Re: Remedial Action Work Plan Addendum
Site Remediation File No. SR-26-0934A/Formerly RIDEM Case No. 95-022
Former Tidewater Facility
200 Taft Street
Pawtucket, Rhode Island

GZA GeoEnvironmental, Inc. (GZA), on behalf of The Narragansett Electric Company d/b/a National Grid (National Grid), has prepared this addendum to the June 2018 *Remedial Action Work Plan* (RAWP) for the Former Tidewater Facility located in Pawtucket, Rhode Island (herein referred to as the Site). This addendum serves as our response to your *RAWP Comment Letter* dated February 8, 2019.

RESPONSES TO RIDEM'S FEBRUARY 8, 2019 COMMENT LETTER

GZA--\\A:ENVA 43654.40\CAD\01_CURRENT\PLANS\RIDEM-WRAP-COMMENTS-2019-05-14\43.645.40_CD_C-REA-OVERALL.DWG 31 OVERALL REMEDIAL ACTION PLAN MAY 30, 2019 1:29PM SCOTT BUXTON

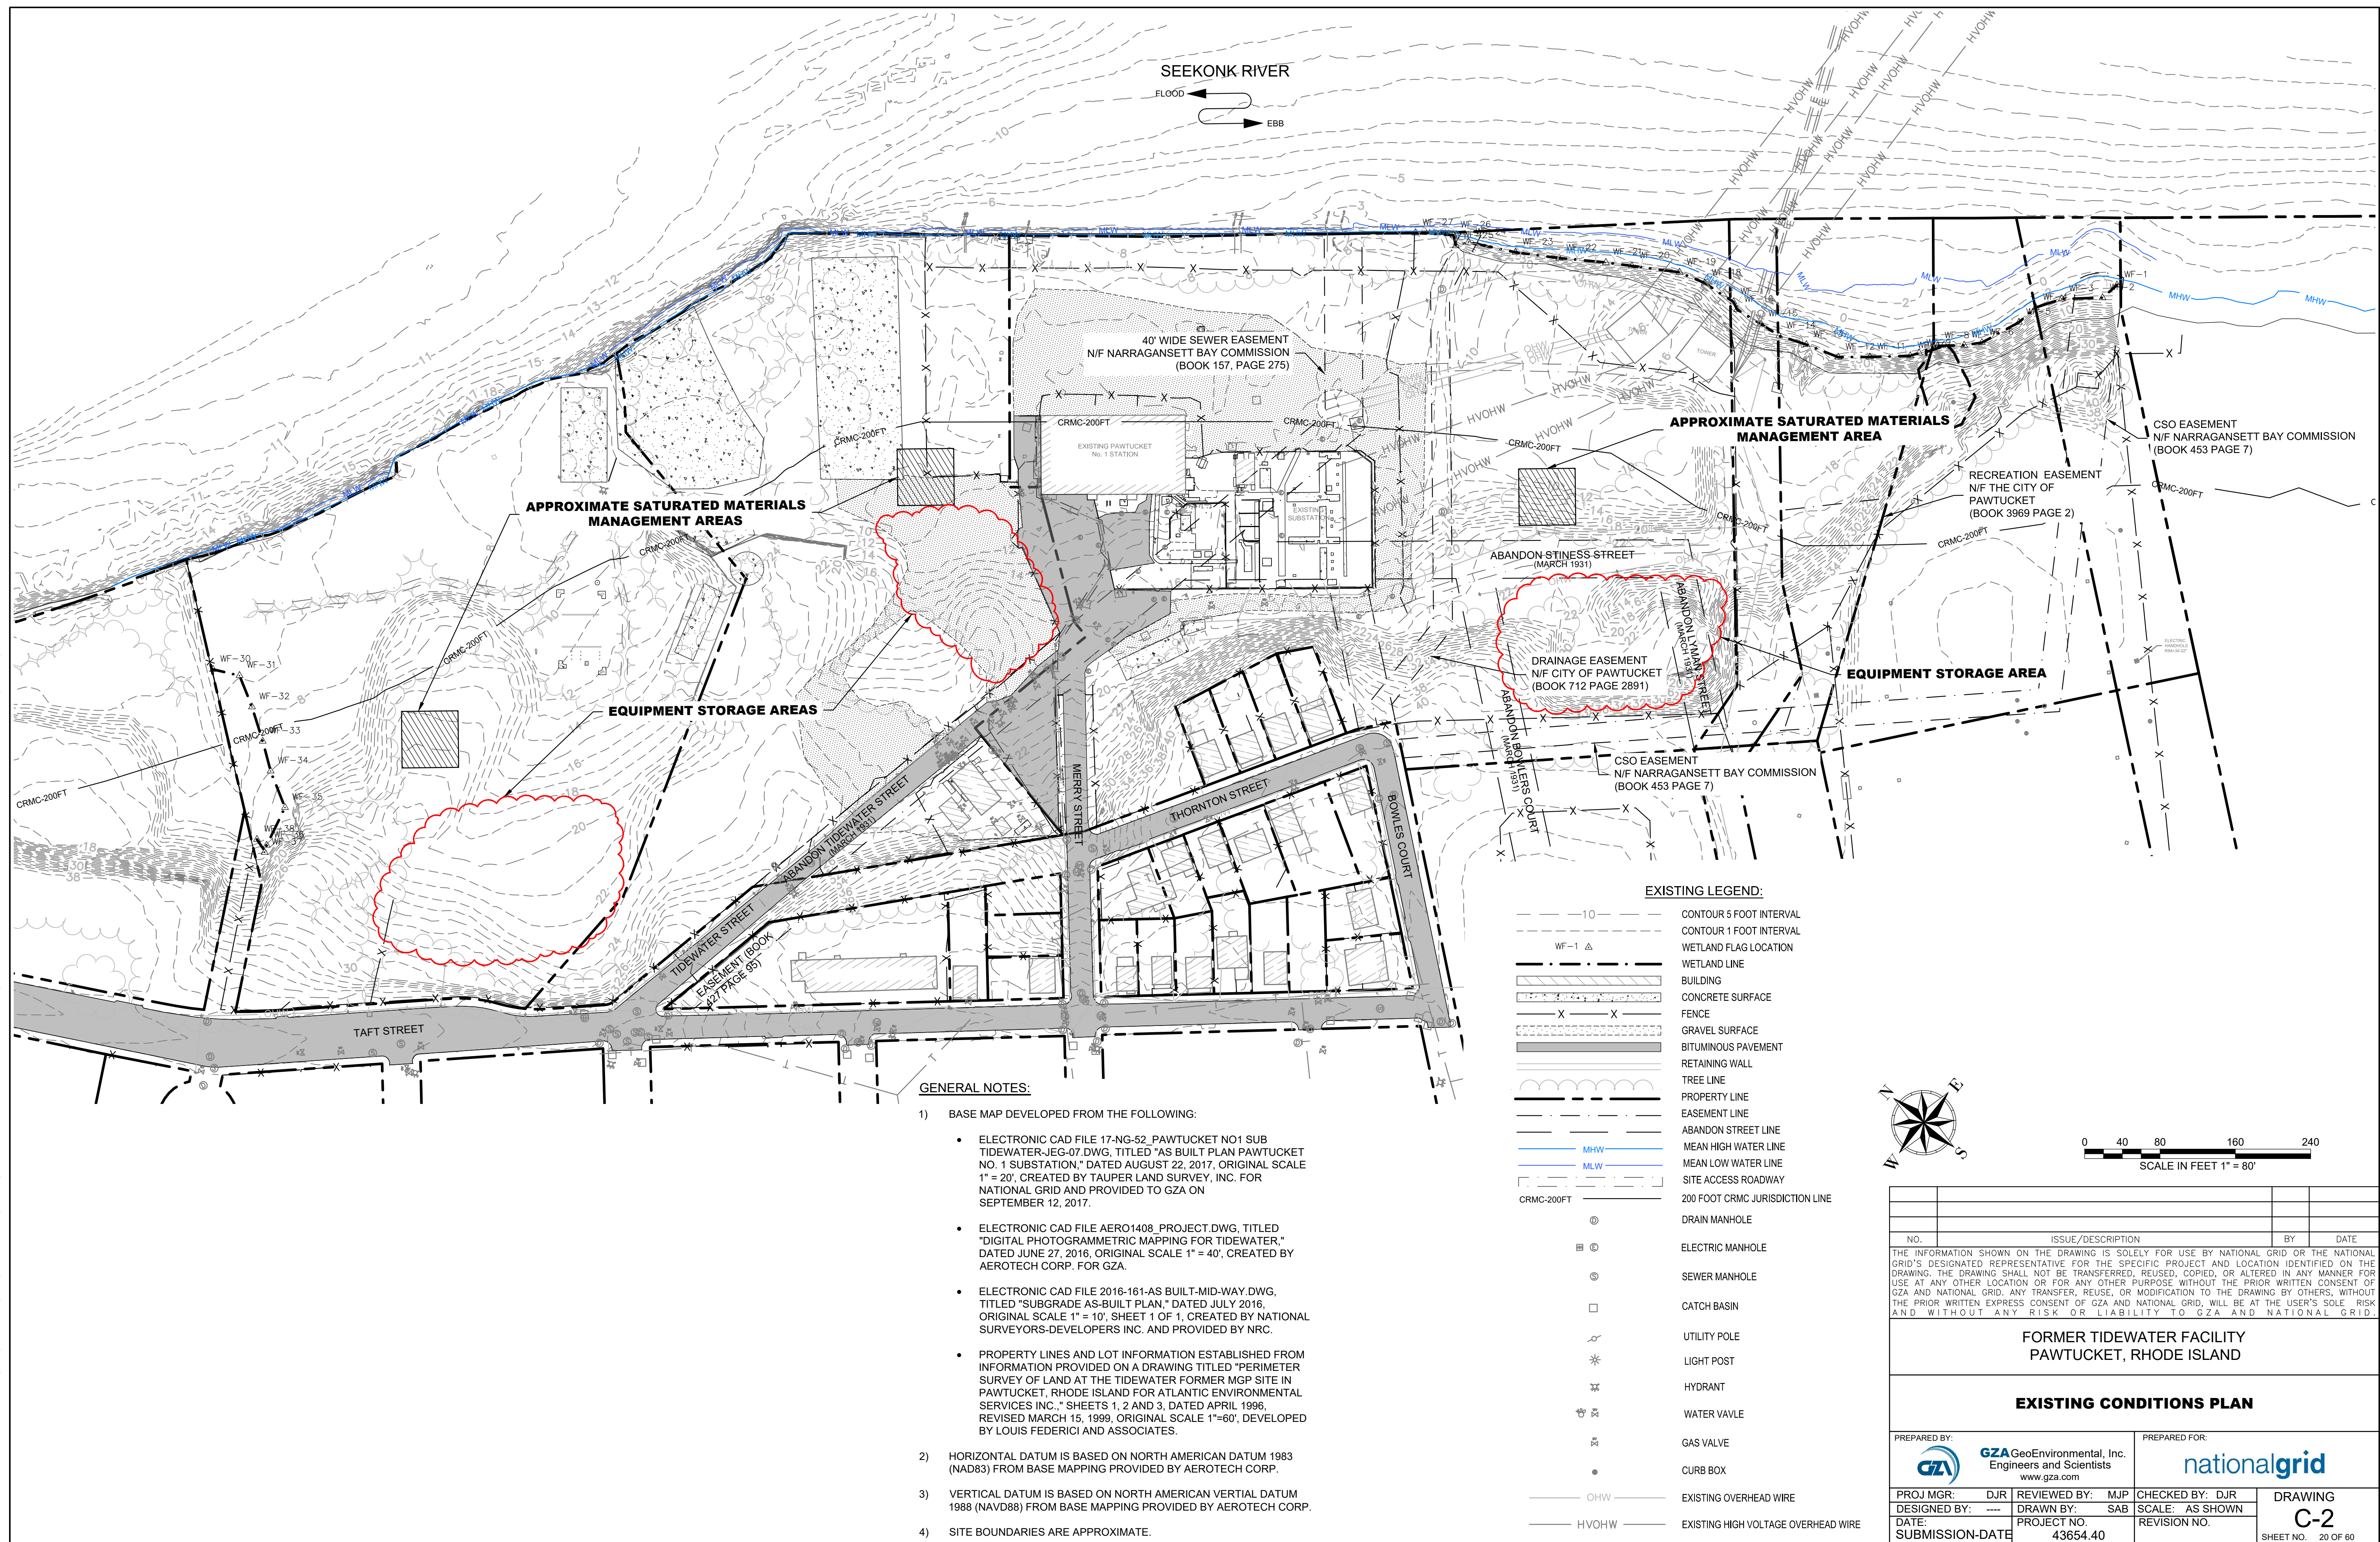
RIDEM Comment 1: RAWP Section 11.10.4 (Soil Management Techniques) indicates:

- a. "Dry (non-saturated) excavated materials will be staged on-Site directly on the existing ground surface". It is the Department's position that staging of the excavated materials directly on the existing ground surface may only be done in areas of the Site that are scheduled to be capped at a later time, and only if the materials are compliant with the Department's GB Leachability Criteria (GBLC). Otherwise impacted excavated materials must be staged on polyethylene sheeting or in containers.

RIDEM Comment 4: As discussed with representatives of National Grid and GZA at the December 13, 2018 Site visit, please consider options for placement of monitoring wells downgradient of the containment wall. This remedial approach has been implemented at several other Sites in Rhode Island and provides a way to demonstrate that the containment wall is functioning as designed to prevent the off-site migration of contaminated groundwater.

As indicated in the RAWP, performance of this re-grading will require that certain materials be temporarily staged on the ground surface near the point of excavation and near the point of filling as the work progresses. However, as described below and as depicted on the attached updated Figure 18 from the RAWP, we propose to extend the impermeable cap conservatively to the northern Site boundary. Given this extension, most of the Site will now be covered with an impermeable engineered cap and all temporary staging of soils will be conducted in areas that will be subsequently capped.

Response: As shown on the attached updated Figure 18 from the RAWP, the central portion (approximately 580 feet) of the approximately 1,125-foot long containment wall will serve as a bulkhead between the land-based portion of the Site and the Seekonk River. In this portion of the containment wall, it is not feasible to install monitoring wells downgradient of the containment wall.

In the remaining sections of the containment wall, it will be feasible to install monitoring wells in a few isolated locations where land is available between the downgradient side of the containment wall and Mean High Water (MHW). As indicated on the attached updated Figure 18 from the RAWP, we anticipate the installation of 4 monitoring wells downgradient of the containment wall (2 wells downgradient of the northern portion of the containment wall and 2 wells downgradient of the southern portion of the containment wall). These wells will be equipped with screens extending from the top of the glacial till across the groundwater table to monitor for the presence of light and dense non-aqueous phase liquids (NAPLs).

A freshwater wetland that is apparently fed by groundwater seepage is present in the northern portion of the Site (see the attached updated Figure 18 from the RAWP). Consistent with the upland remedy for the Site, this freshwater wetland area will be capped to mitigate direct contact with potential impacted soils. The cap in this area will be

We do not anticipate performing work within the tidal wetland identified in the southeastern portion of the Site (see the attached updated Figure 18 from the RAWP).

- GZA's licensed soil scientist performed a survey of the Site as part of the remedy design and permitting process. Based on this survey, a tidal wetland was identified in the southeastern portion of the Site proximate to the proposed southern section of the containment wall. In addition, we have also become aware of the presence of electrical distribution submarine cables proximate to the south transmission tower. These submarine cables extend from a utility pole on the Site, below the river and to the eastern shore of the Seekonk River. As described in our April 2, 2019 letter which is attached to this RAWP Addendum, in order to minimize impacts to the tidal wetlands and due to concerns regarding installation of a steel sheet containment wall proximate to submarine cables, we propose to replace the southern section of the containment wall in the southeastern portion of the Site with a row of seven (7) 4-inch diameter recovery wells installed approximately at the mid-slope of the riverbank. This well based recovery system is adequate to address the limited NAPL observed in this area of the Site. The recovery wells will be spaced approximately every 20 feet between well couplets farther up the slope where NAPL impacts were not observed during previous investigation activities (i.e., MW-318S/D and MW-319S/D). The bottom of each new well screen will be set at an elevation consistent with monitoring well MW-320D (Elevation -18.1 NAVD 88). In addition, the riverbank will be re-graded to create a uniform slope from the top of the riverbank to the edge of the tidal wetlands and capped with a reactive core mat as a precaution to mitigate the potential migration of NAPL to the shallow river sediments. Figure 18 from the RAWP was updated to depict the approximate layout of these recovery wells.

- GZA's licensed soil scientist also identified a freshwater wetland in the northern portion of the Site which appears to be supported by groundwater seeping from the steep slope directly west of the wetland area. As indicated above, consistent with the upland remedy for the Site, this freshwater wetland area will be capped to mitigate direct contact with the potentially impacted soils in this area. The cap will be designed as a permeable cap to allow groundwater to continue to support the wetland and the area will be restored with wetland soils and plantings. Figure 18 from the RAWP was updated to depict the approximate extent of the freshwater wetland area.

G:\A-1\EN\A 43654.40\CAD\01_CURRENT\PLANS\RIDEM-WRAP-COMMENTS-2019-05-14\A3.645.40_RO_CD_C-FC-OVERALL.DWG 40 OVERALL FINAL CONDITIONS PLAN MAY 30, 2019 1:25PM SCOTT BUXTON

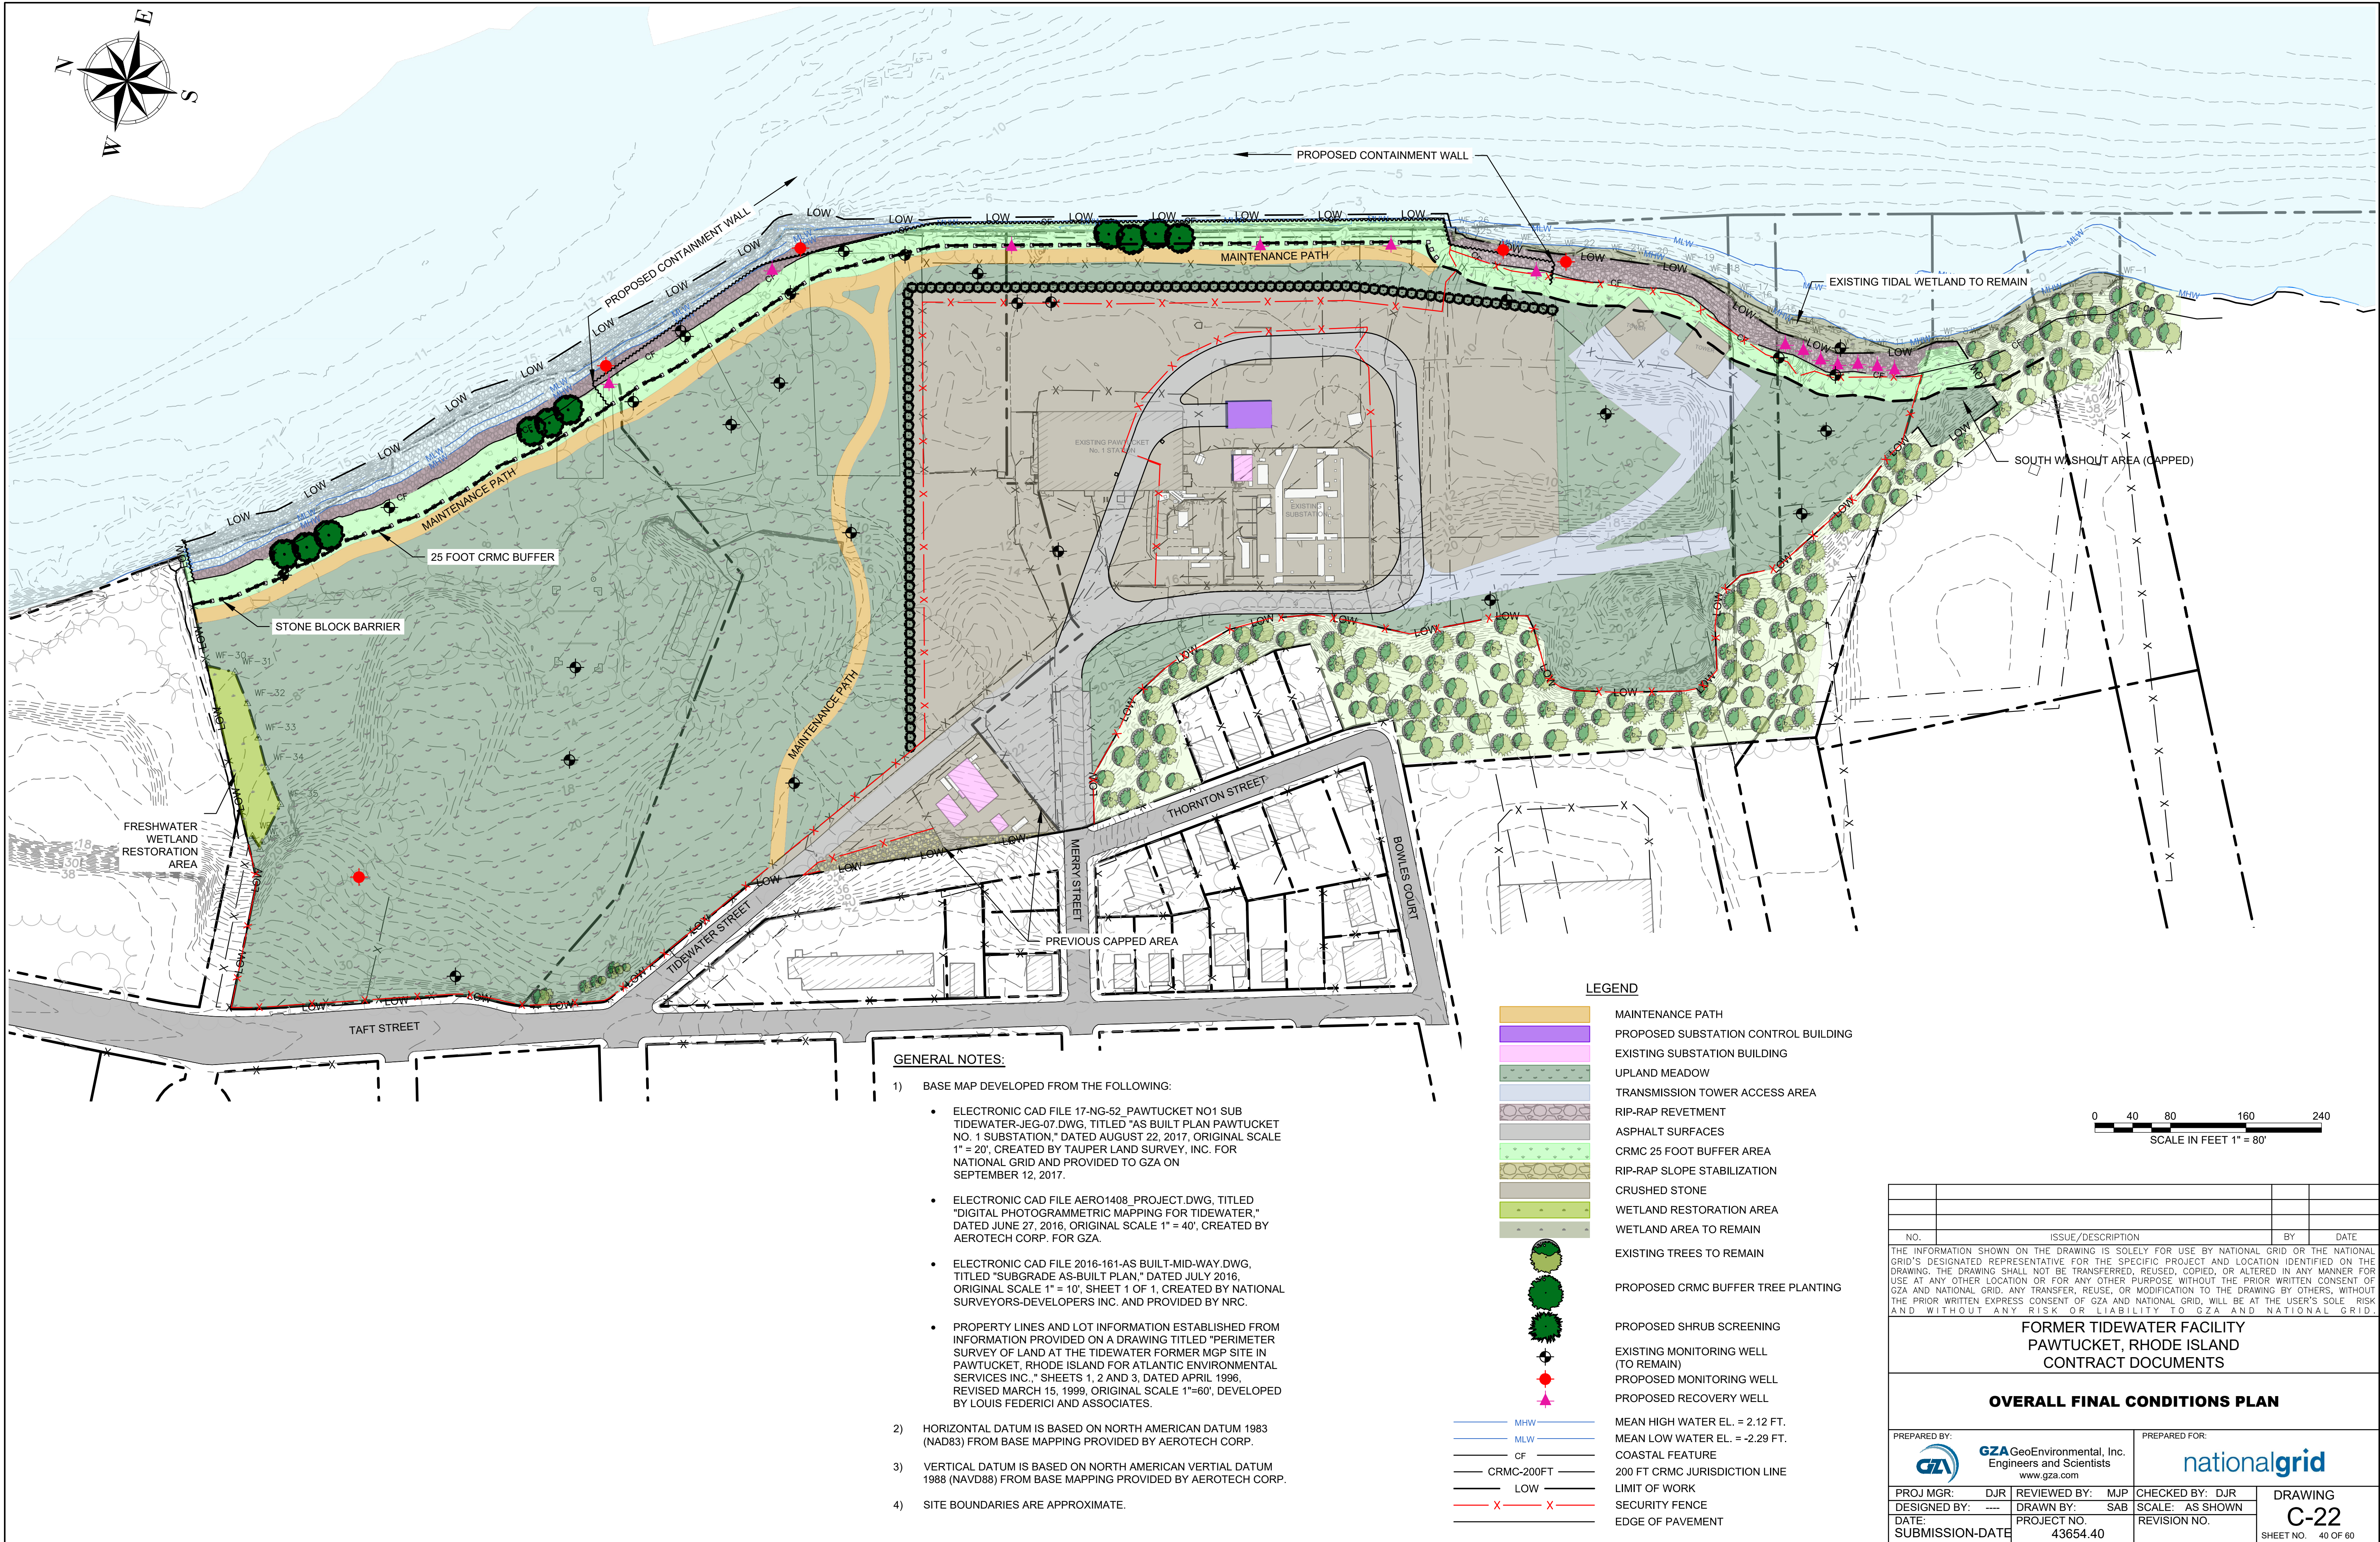
- **CRMC Comment #3:** Restoration of vegetated areas within 200' of the coastal feature is required post-remediation as follows. Current site conditions range from forested slope (southern extreme) to old field/sapling conditions (northern extreme) including development/asphalt/remnant structures. Proposed remediation includes an impermeable geotextile layer. Based on the above, reforestation is not a requirement for this site. However, a re-planting of disturbed areas with shallow-root native vegetation (shrubs and perennial grasses) is possible and will be required as part of Assent review. Any mature trees which can be retained on-site (specifically the southern area was noted to remain undisturbed) should be preserved. The width of the revegetation shall be based on current lot size. Parcels 80,000-200,000 sf on Type 4 waters required a 125' revegetated buffer zone. Parcels <200,000 sf require a 150' vegetated buffer zone. This revegetation shall only apply to those areas currently vegetated for purposes of this upcoming Assent review.

Response: As discussed during the April 2019 pre-application meeting, a 25-foot vegetated buffer will be installed along the entire riverfront. The vegetation within this buffer zone will consist of native species consistent with CRMC's Coastal Buffer Zone Planting Guide, Revised August 2008 with shallow root systems compatible with the engineered cap.

In the northern and southern portions of the Site, the upland area to the west of the 25-foot wide buffer will be re-vegetated with a meadow grass seed mix to minimize the maintenance of the engineered cap in these areas.

At the request of the City of Pawtucket, vegetation will also be planted to the north and east of the substation area to screen the substation from the river and the northern portion of the Site. This screening vegetation will also consist of native low maintenance species with a shallow root system compatible with the engineered cap.

A preliminary Overall Final Conditions Plan showing the extent of the buffer zone, the extent of the upland meadow, and the substation screening is attached for reference. The combined permit application package submitted to the regulatory agencies will include an updated version of this plan that identifies the type and density of plant species within the buffer zone and for the substation screen.
